Technical Service Bulletin

43 Air suspension system fault - DTC C118D01 Compressor for level control electrical error

43 24 90 2073034/5 May 14, 2024. Supersedes Technical Service Bulletin Group 43 number 24-88 dated May 7, 2024 for reasons listed below.

Figure 1. Verify that the compressor electronics is part number 4M0.907.778.A.

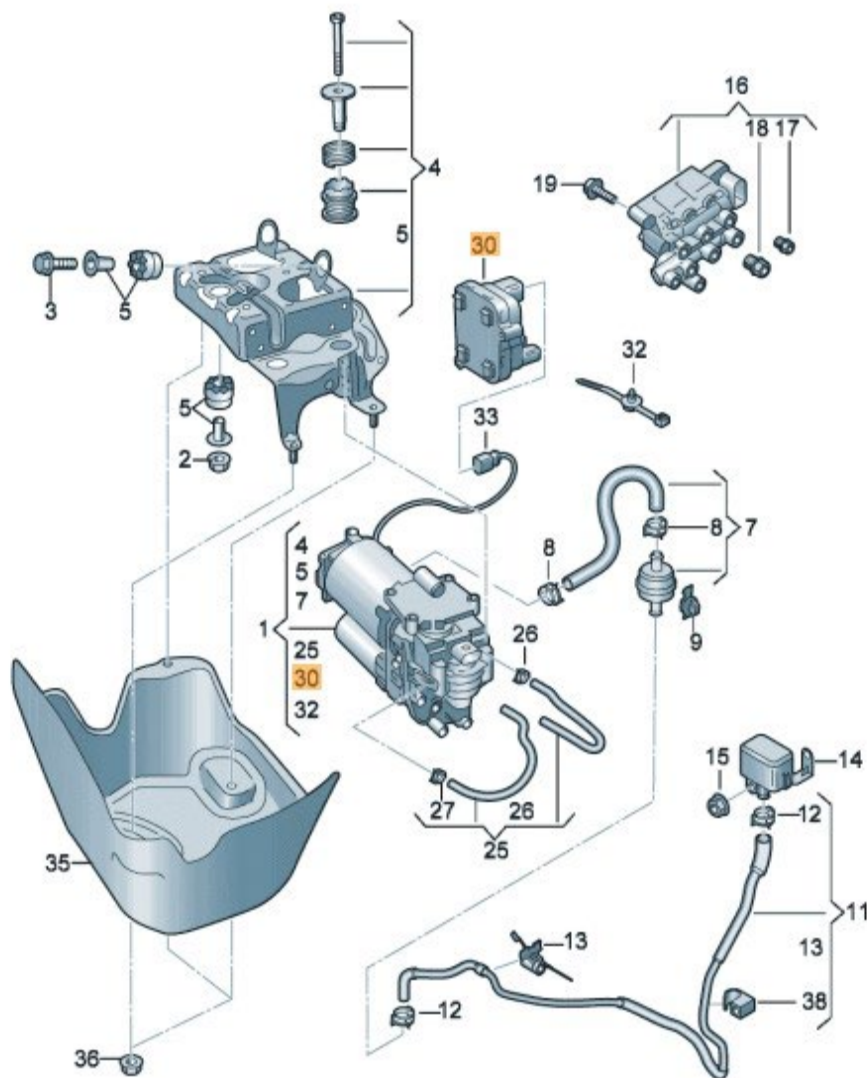
The described procedure only applies if compressor electronics with part number index A are fitted in the vehicle (affected part number 4M0.907.778.A) (Figure 1, number 30).

- If the DTC is **passive/intermittent**, delete the DTC.
- If the DTC is logged as **active/static** and remains active/static after the ignition is switched off and then on again, replace the control unit for compressor electronics J1135 (**not the air compressor**).
- Please use part number **4M0.907.778 (Without index A)**.
